TO: DEVELOPMENT REVIEW BOARD
FROM: CURRENT PLANNING SERVICES
SUBJECT: CASE 37-DR-2002#2
REQUEST: Approve site plan & elevations for an office building with fill greater than 8 feet
PROJECT NAME: 136th Street Office Building
LOCATION: 11440 N 136th St

DATE: November 20, 2003

Stipulations for Case: 136th Street Office Building 37-DR-2002 #2

ELEVATIONS

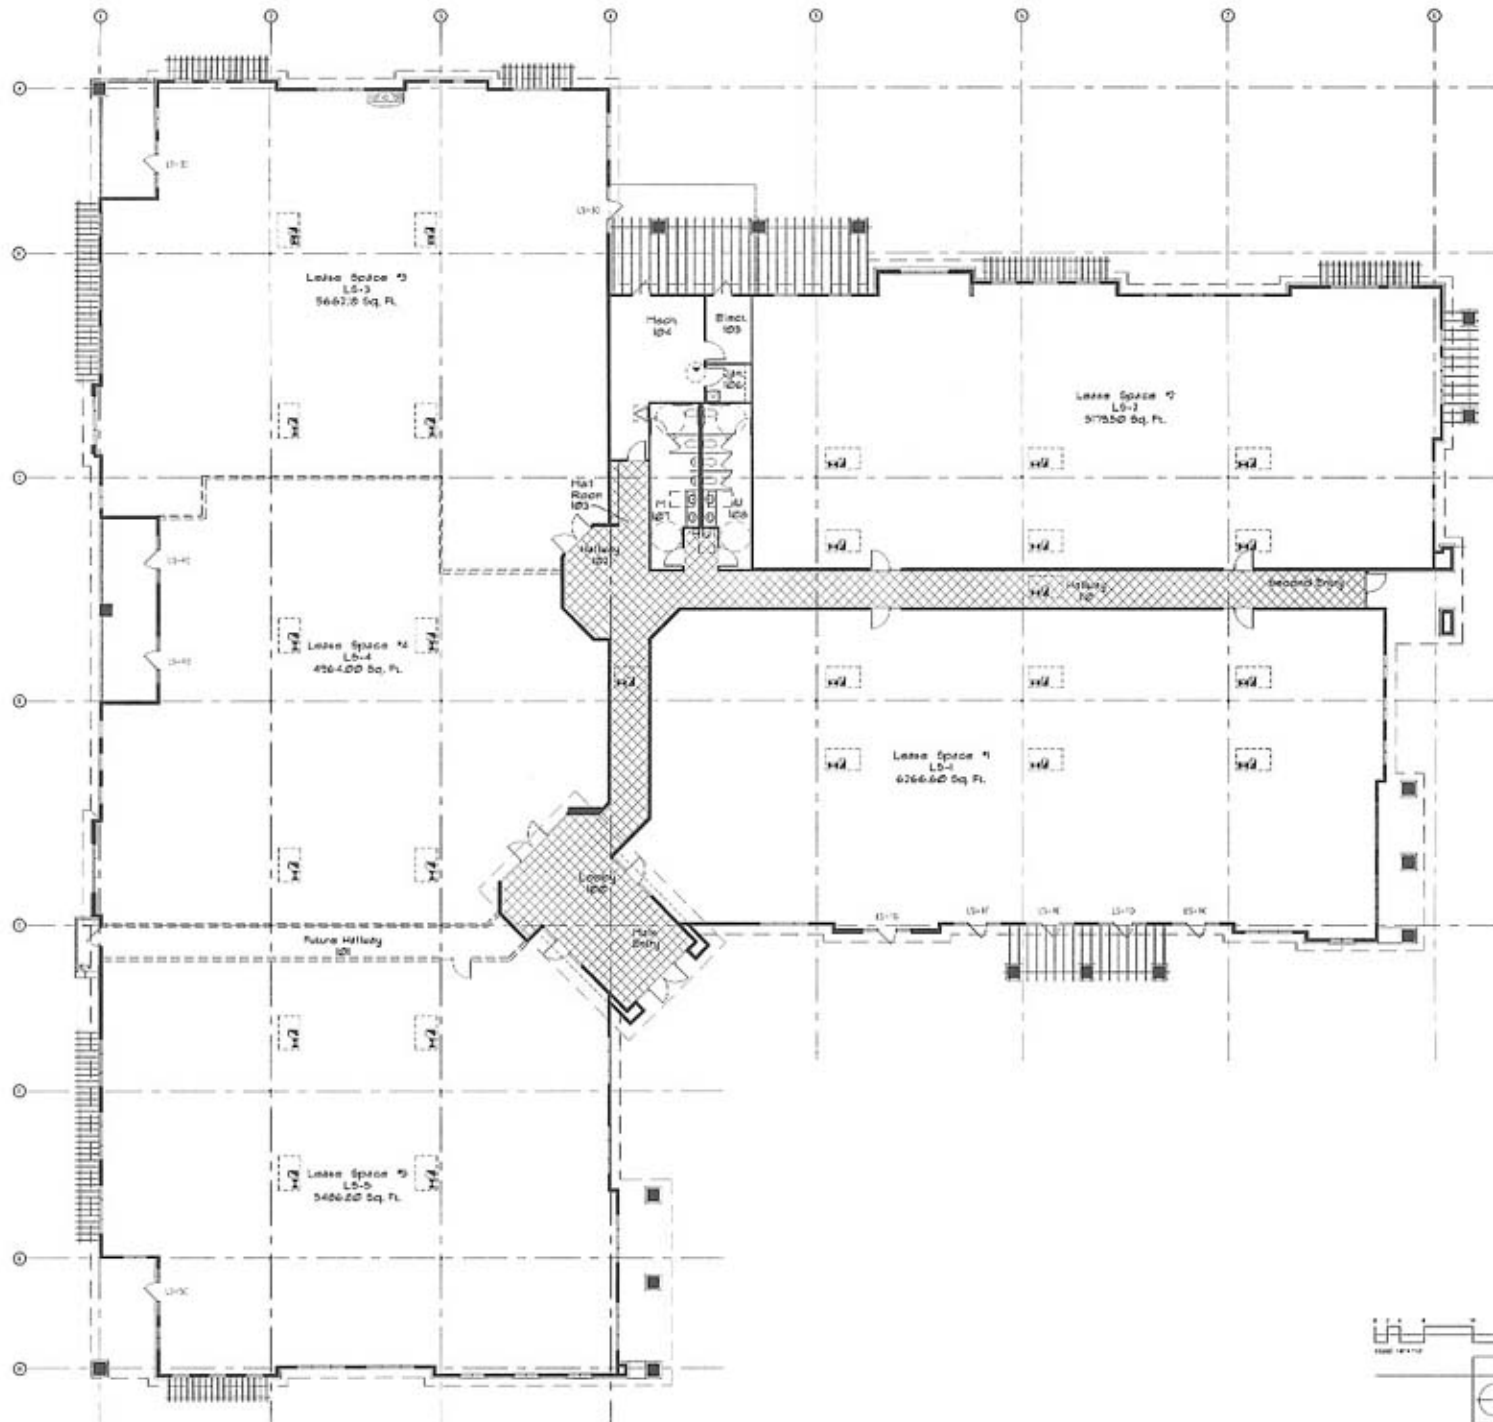
2. With the final plans submittal, the building elevations shall be revised to illustrate the design of the site wall shown on the approved site plan at the southwest corner of the site. The site wall shall be wrapped around to the west elevation, as approved by Project Coordination staff.

3. Windows shall be recessed a minimum of 50% of the wall depth.
4. Building design shall be revised to extend building eaves (roof overhang) a minimum of 36 inches from the wall plane, to the satisfaction of city staff.

5. With Final Plans submittal building elevations shall be revised, to the satisfaction of city staff, to:
 - a. thicken the building fascia,
 - b. include the use of stone veneer to the top of the trellis columns instead of as a wainscot, and

- c. widen the rake detail of the gable ends.
6. The service entrance section(s) shall be flush with the building façade and painted to match the building.

Figure 9.

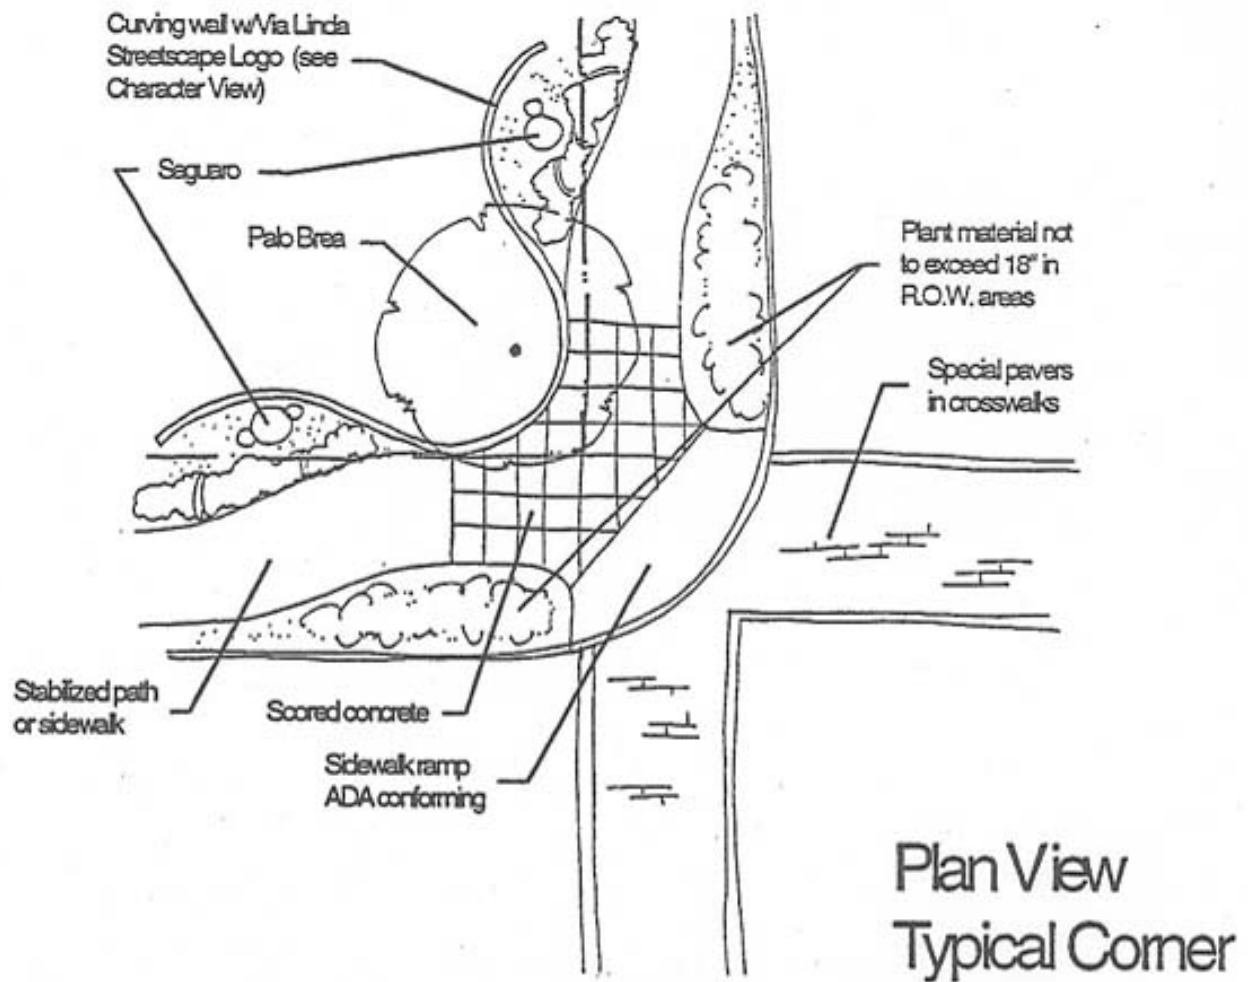
13. With the Final Plans submittal, Site Plan, Grading and Drainage Plan and Landscape Plan shall be revised to show the required improvements for the intersection of 136th Street and Via Linda Road, as identified in Figure 9 of the Council-approved Via Linda Streetscape Guidelines, to the satisfaction of city staff. These improvements include a curving wall with Via Linda Streetscape Logo (see Figure 5 of the Guidelines), Saguaros, Palo Brea trees, and scored concrete paving where sidewalks from 136th Street and Via Linda Road intersect.
14. Maximum wall height shall be eight (8) feet.
